MEMORANDUM
To: Auburn Planning Board
From: Natalie Thomsen, Planning Coordinator
Date: June 10, 2025
Re: Brickyard Commons – Site Plan Review and Subdivision Exemption Determination

To: Auburn Planning Board
From: Natalie Thomsen, Planning Coordinator
Re: JIG Investments, LLC, for a Site Plan Review application for a 96-unit apartment complex with associated site improvements and infrastructure located on Brickyard Circle, Tax Map Lot 199-052-000. The proposed project should be considered pursuant to Chapter 60, Article XVI Division 2 – Site Plan Review, Article IV, Subdivision, Article IV, Division 14 – Form Based Code
Date: June 10, 2025

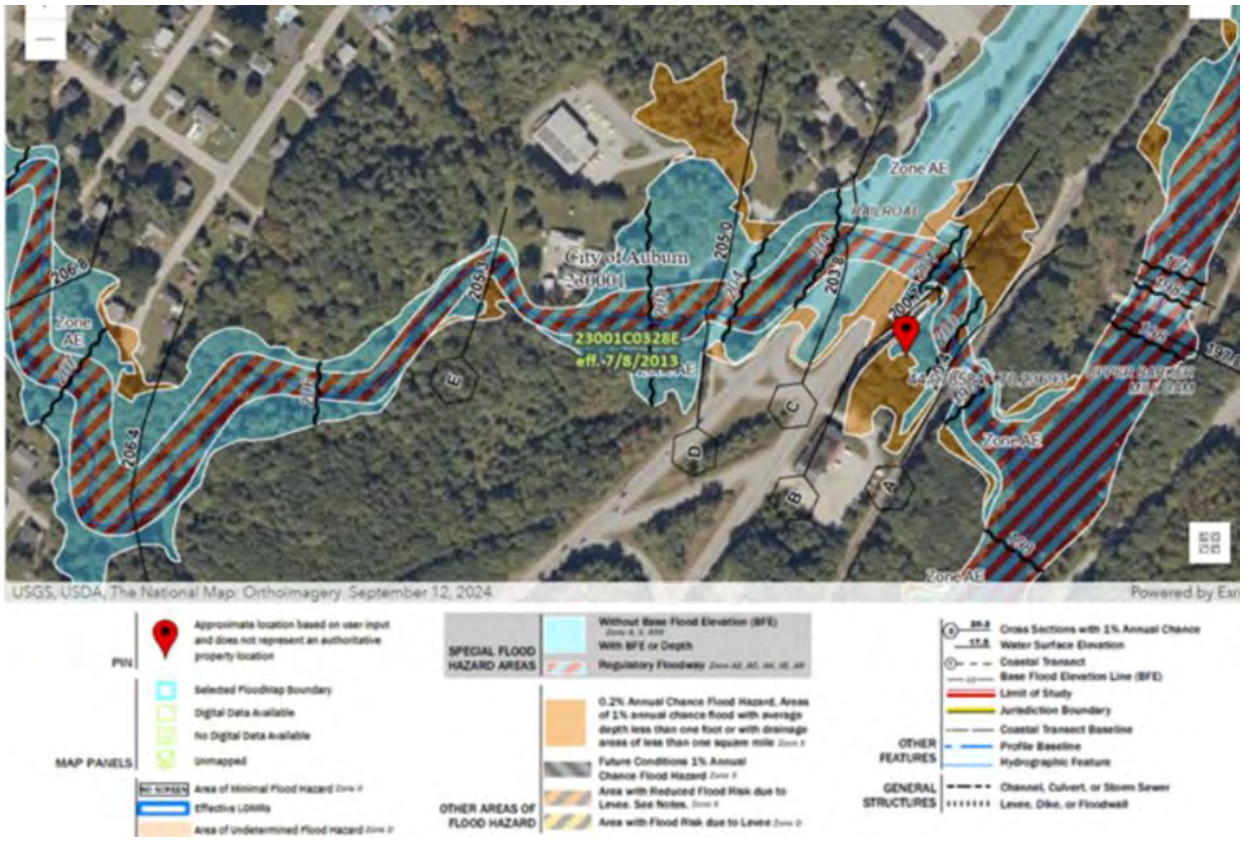
First of all – At an Eagles eye view, this parcel may now, indeed be recently zoned as T5.1, (What was originally industrial just a few years ago), but por ons of it, s ll fall within the Floodplain district, Shoreland overlay district & wetlands (including those of state sign ance). This is partly why they need special approval from Auburn Planning Board & Sta . These are just some of the numerous reasons this was triggered for Special Review before the Planning Board.

Below is most accurate info. From FEMA Flood plain maps I can share with you.
